# Access Compliance Report

## Public Rights-of-Way

Intersection ID: 49388	Main Street: SHORTHORN_ST	Cross Street: DAMASCUS_ST	Location: NW
ADA ID: 4A3C0FD65518	Ramp Type: PerpDiag	Initial Pass/Fail: Fail	Overall Compliance: No
Codes/Mitigation Info/Possible Solution		Field Measurements/Component Compliance

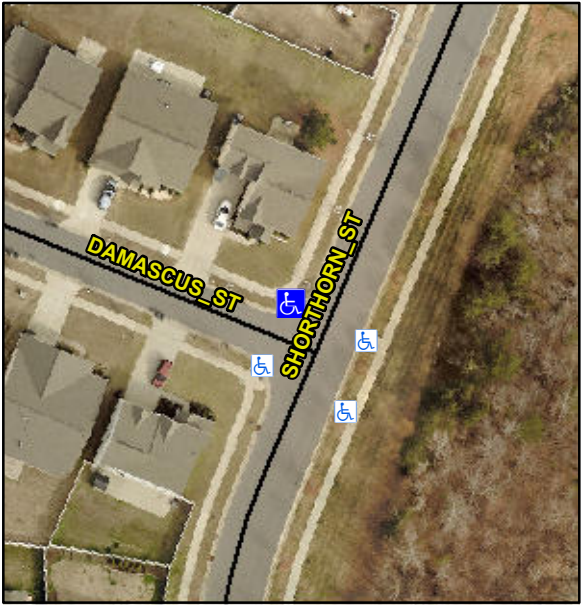
Possible Solutions:	Compliance	Description	Data	Compliance	Description	Data
	Remove & Replace Curb Ramp With Two New Directional Ramps or Equivalent.	N/A	Ramp Length (in)	71.0	No	Ramp Slope (%)	10.4
<p>Surveyor Notes:</p> <p>N/A</p> <p>PROW/ADA:</p> <p>Not Found, R304.5.1, R304.2.2, R304.5.3</p>		No	Ramp Width (in)	47.5	No	Ramp XSlope (%)	6.7
		N/A	Flare Type LT	N/A	N/A	Flare Type RT	N/A
		N/A	Flare Slope LT (%)	N/A	N/A	Flare Slope RT (%)	N/A
		N/A	Flare Traversable LT?	N/A	N/A	Flare Traversable RT?	N/A
		N/A	Landing Length (in)	N/A	N/A	DWS Provided?	N/A
		N/A	Landing Width (in)	N/A	N/A	DWS Contrast?	N/A
		N/A	Landing Slope (%)	N/A	N/A	DWS Length (in)	N/A
		N/A	Landing X Slope (%)	N/A	N/A	DWS Full Width?	N/A
		N/A	Landing Curb? (Y/N)	N/A	N/A	DWS Offset (in)	N/A
		N/A	Shared Landing?	N/A			
		N/A	Gutter Ponding?	N/A	N/A	Gutter Slope (%)	N/A
		N/A	Gutter Lip Ht (in)	N/A	N/A	Gutter X Slope (%)	N/A
		N/A	Painted X Walk1?	No	N/A	Painted X Walk2?	No

X Walk 1 Direction	To SW		X Walk 2 Direction	To SE
		N/A	X Walk 1 Width (in)	N/A	N/A	X Walk 2 Width (in)	N/A
			X Walk 1 Slope (%)	3.0		X Walk 2 Slope (%)	1.3
			X Walk 1 X Slope (%)	2.8		X Walk 2 X Slope (%)	5.3
		N/A	Ramp inside XWalk1?	N/A	N/A	Ramp inside XWalk2?	N/A
			Road Slope (%)	6.2	N/A	Clear Space?	N/A
			Road X Slope (%)	2.7	N/A	Clear Space to XWalk (in)	N/A
		N/A	Any Obstructions?	N/A	N/A	Storm Grate/Utility Hazard?	N/A
			Obstruction Type			Storm Grate/Utility Type	
				N/A			N/A
					Yes	Surface Condition? (G/P)	Good
